SOLICITATION ADDENDUM NO. 2

Project Title	Date Prepared	Project No.
SJCCD Maritime Expansion Fire Training Center	December 4, 2019	CSP 20-12

ADDENDUM NO. 02

Project: **Maritime Expansion Fire Training Center**
 San Jacinto Community College District

C1.04
 SITE DETAILS

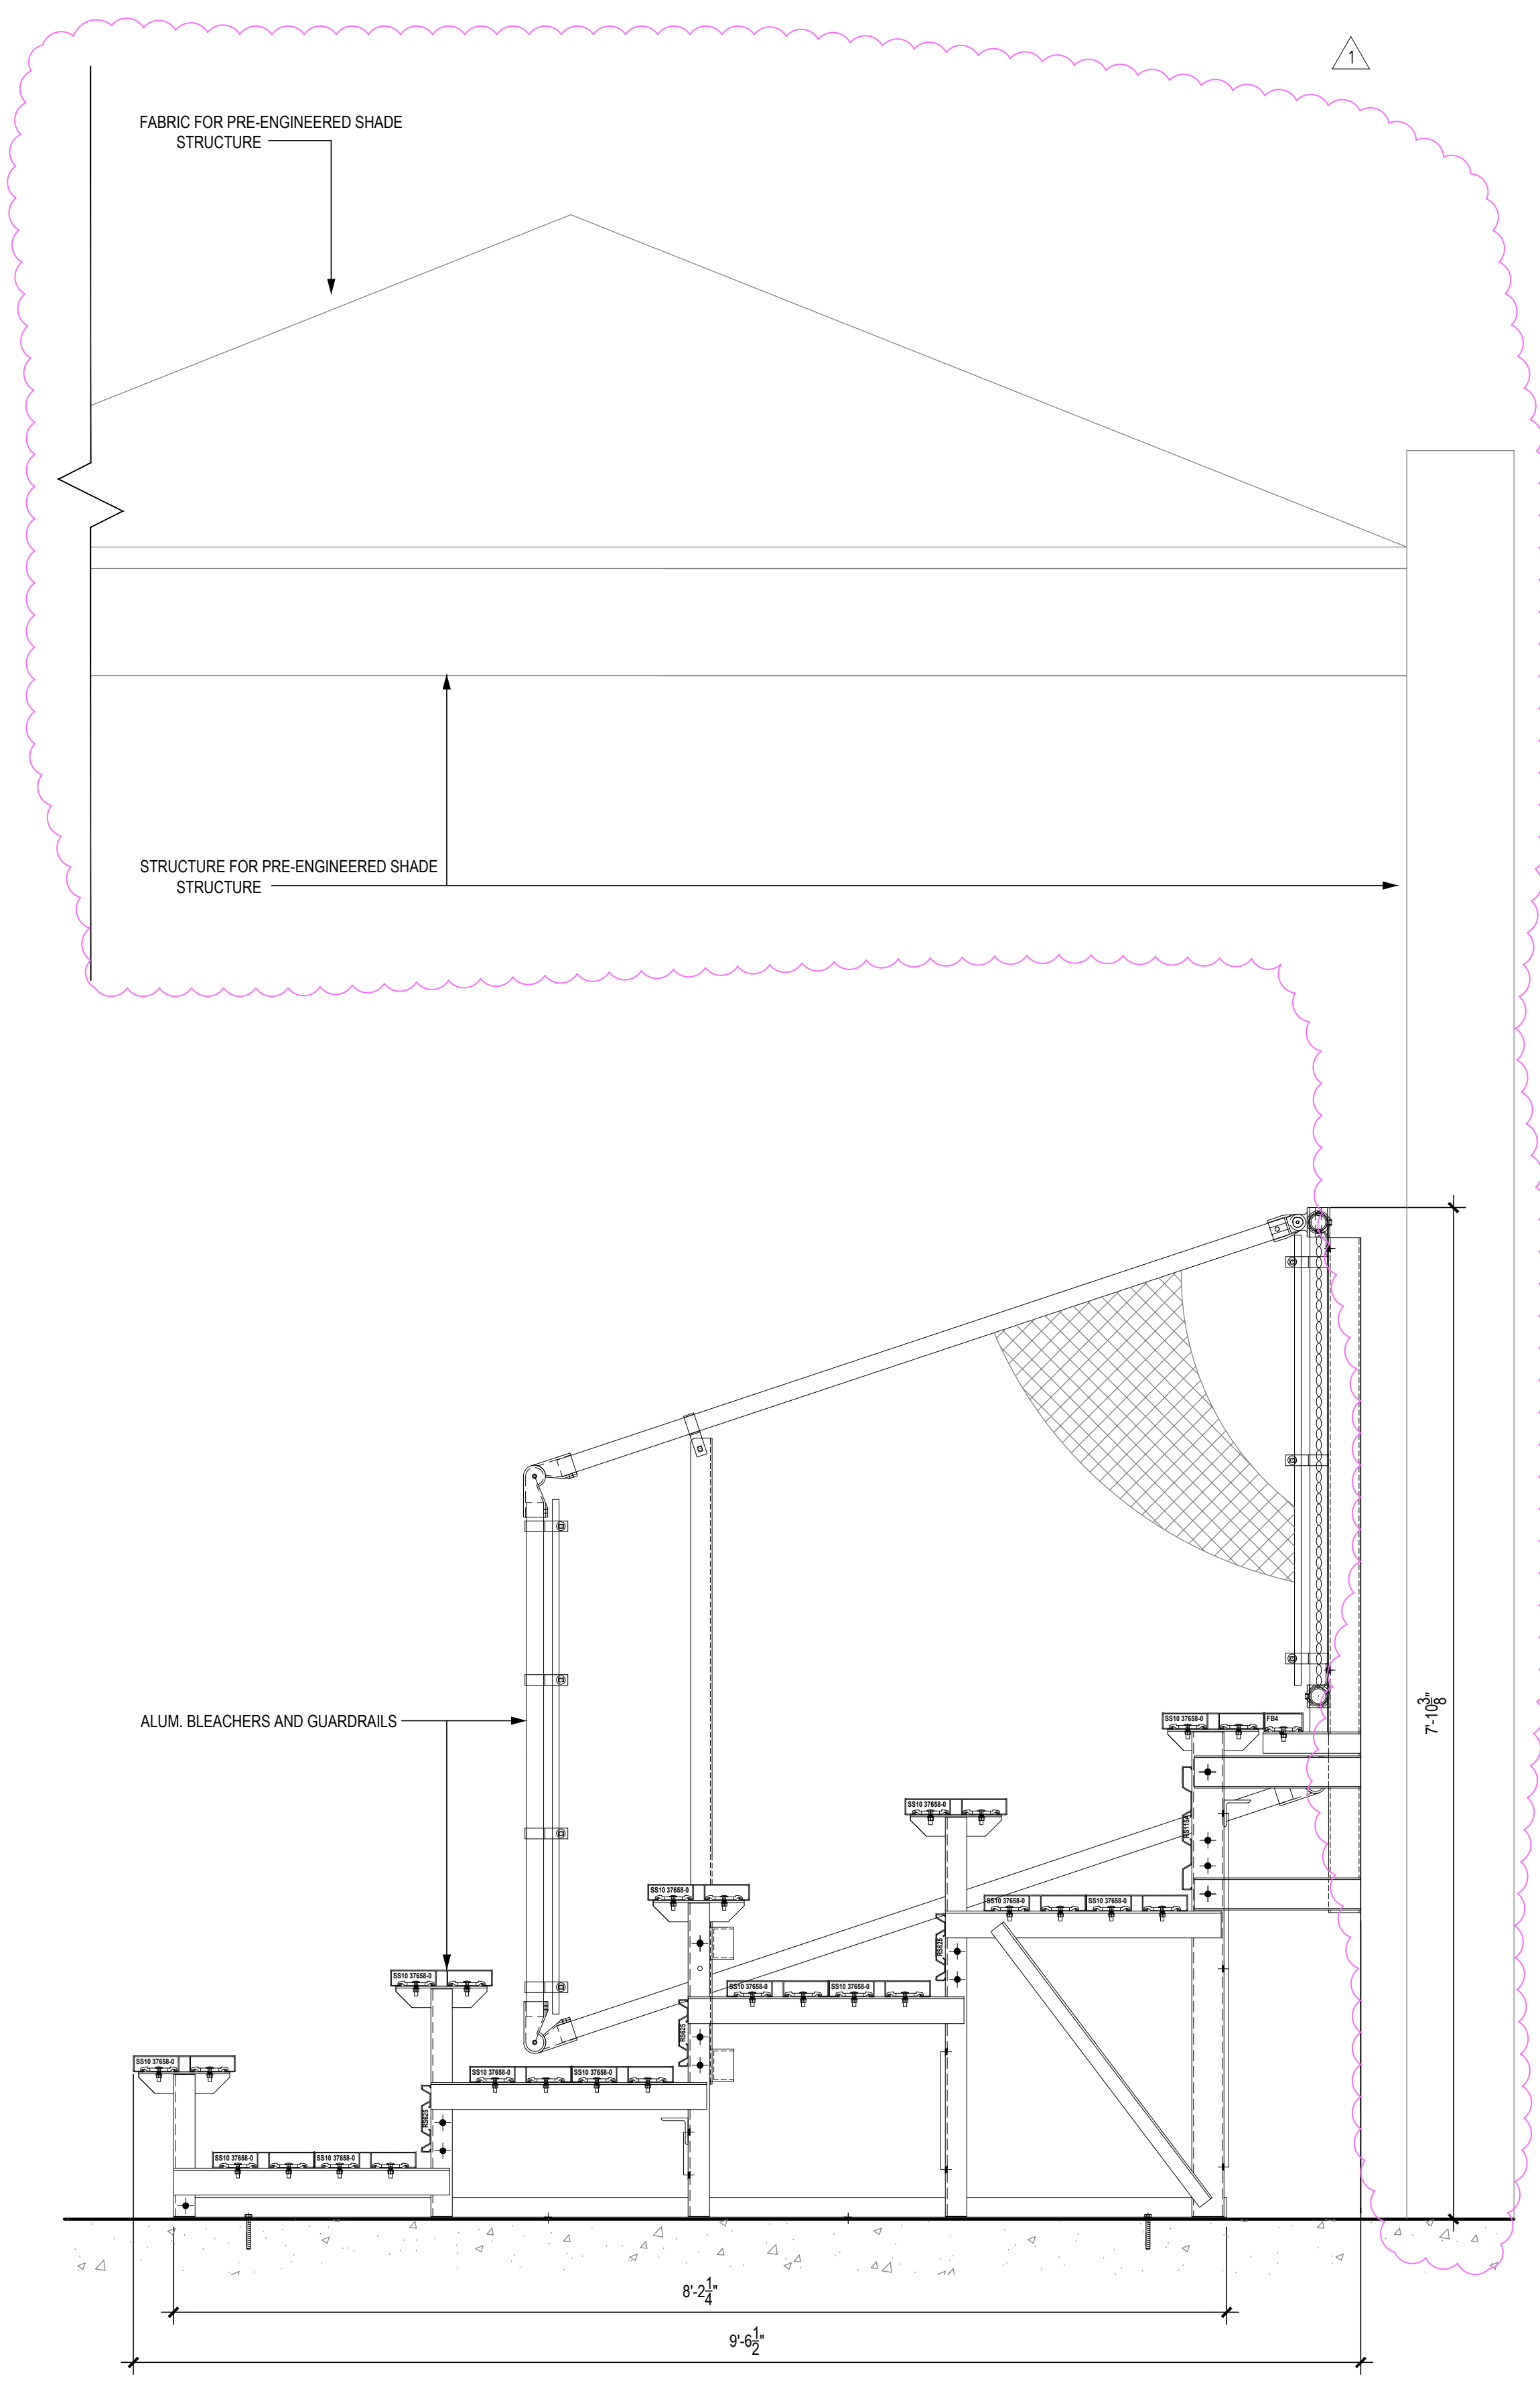
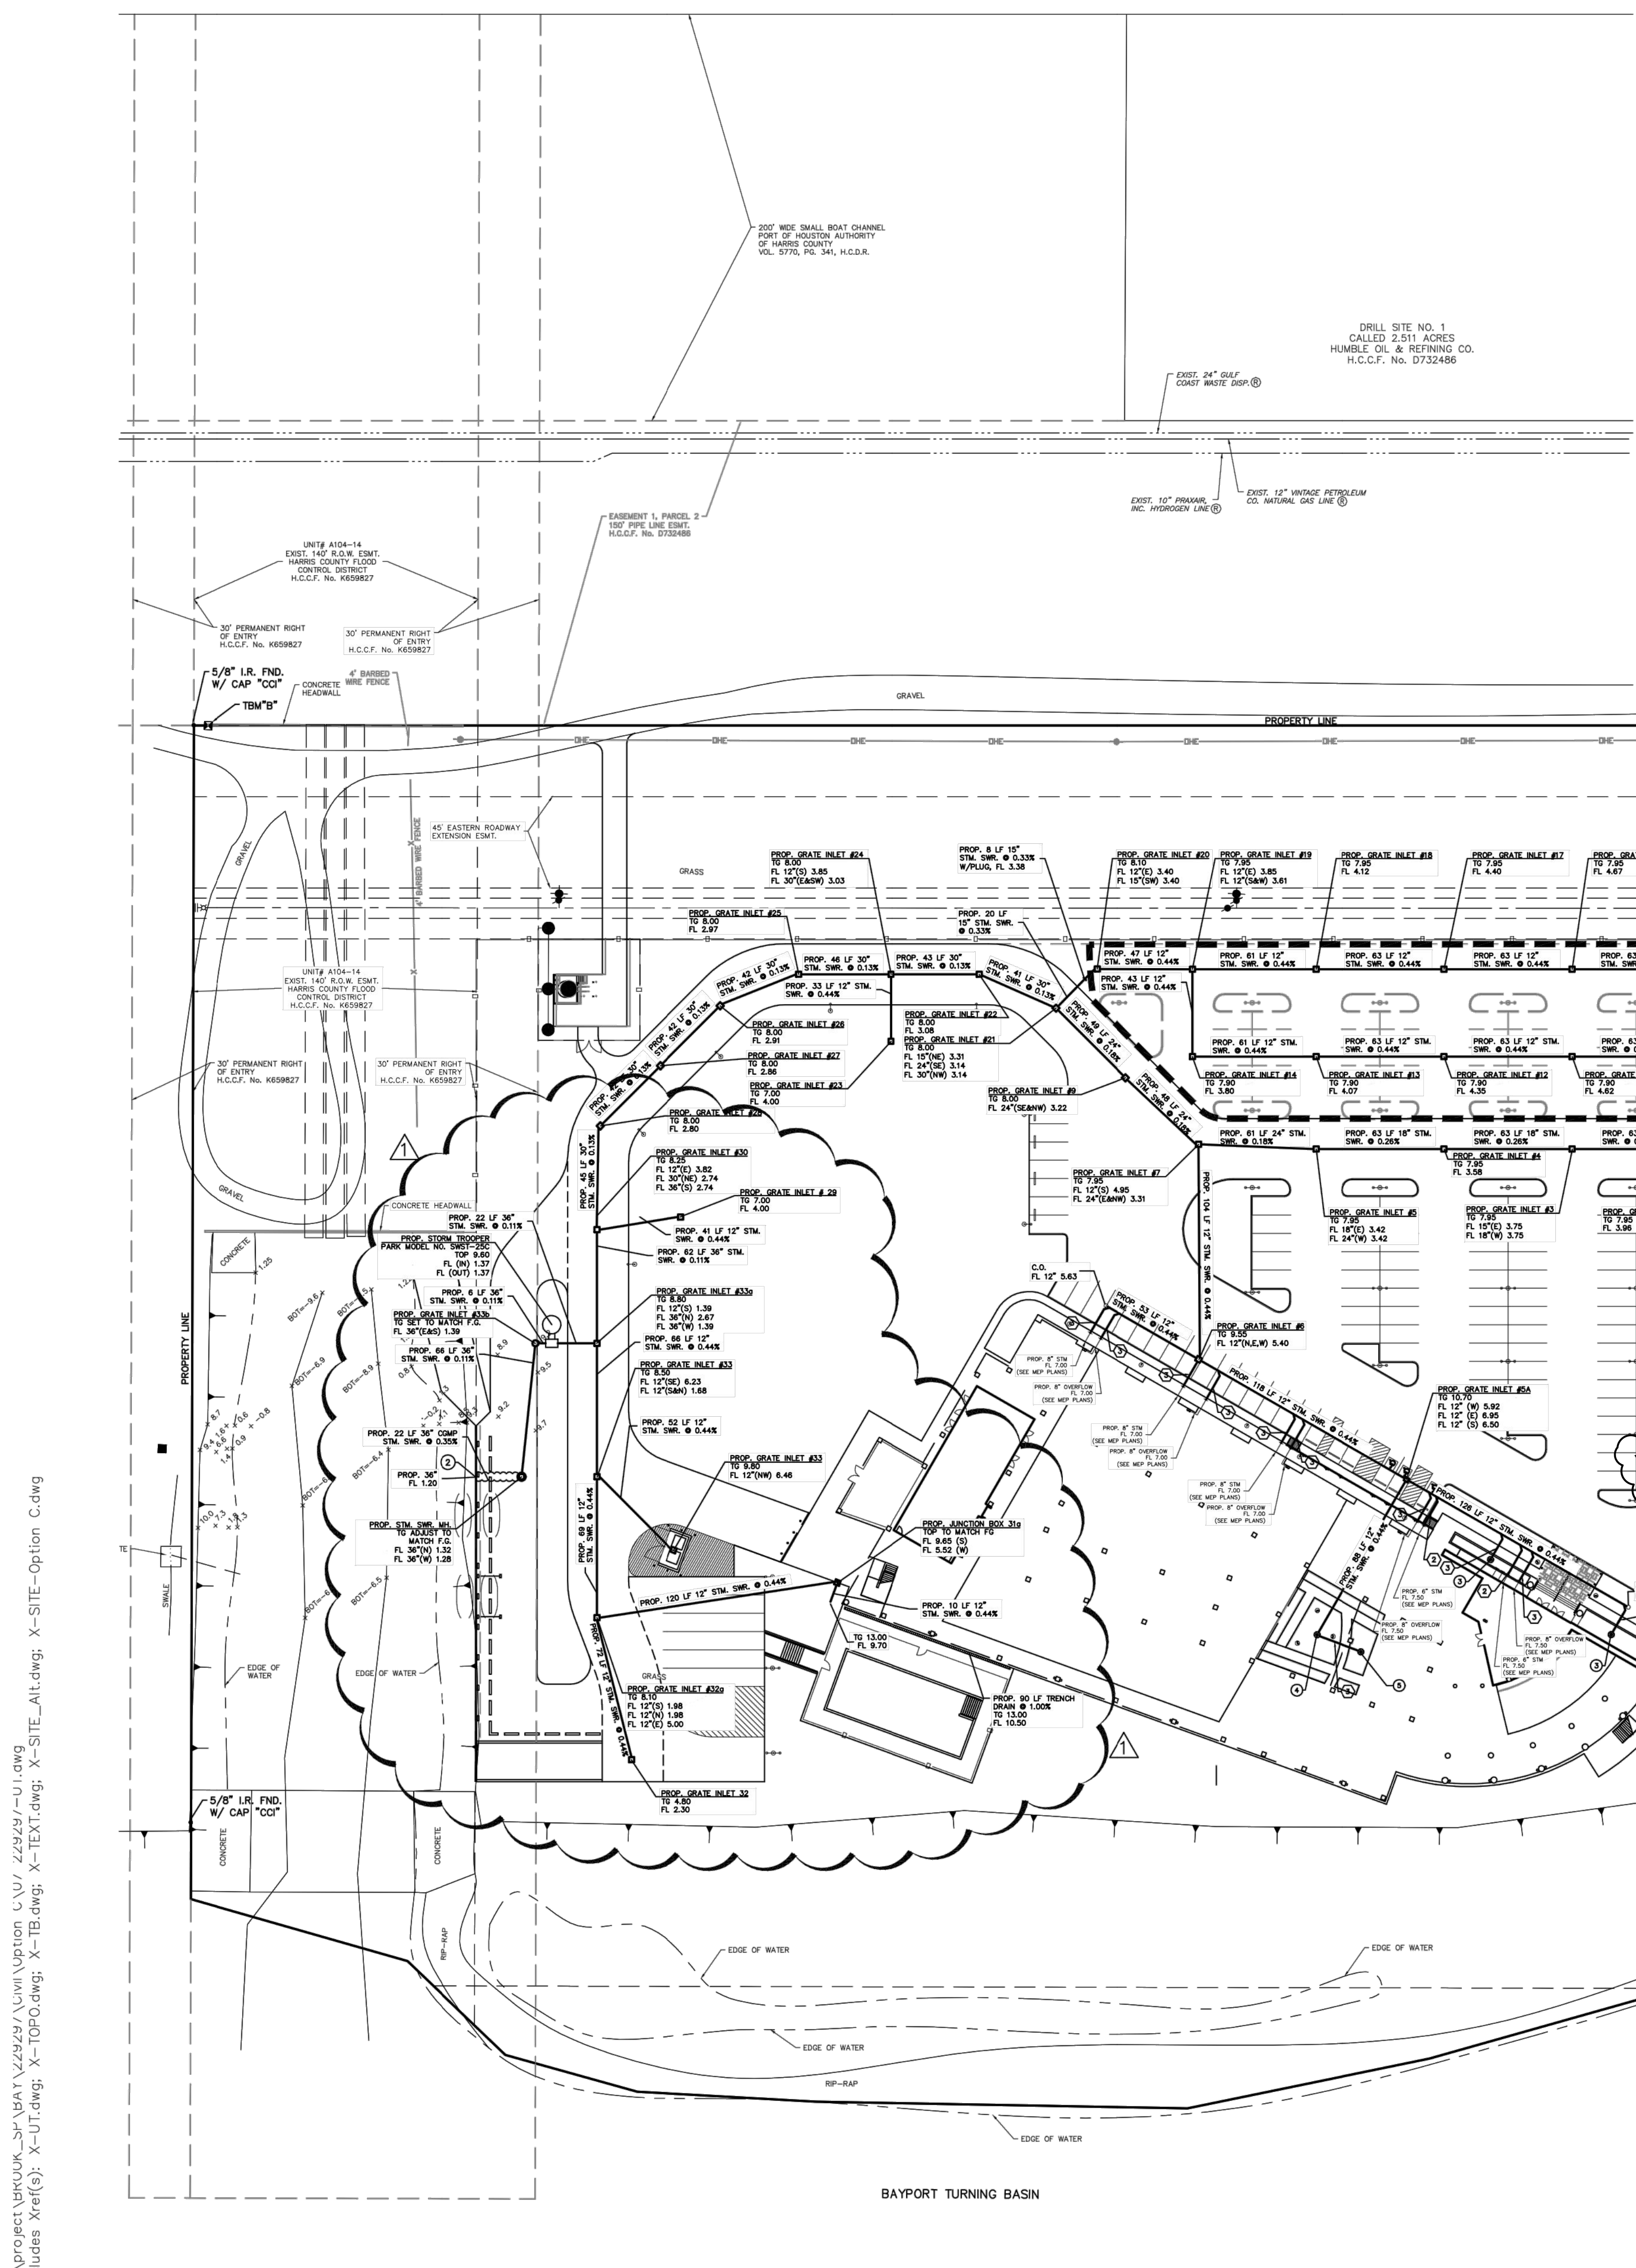
15. Sheet C1.04 – Site Details
 - a. Detail 4 has been revised
 - b. Detail 12 has been revised to show the canopy over the bleachers.
16. Sheet C2.04 – Existing Storm Sewer and SWQ Plan
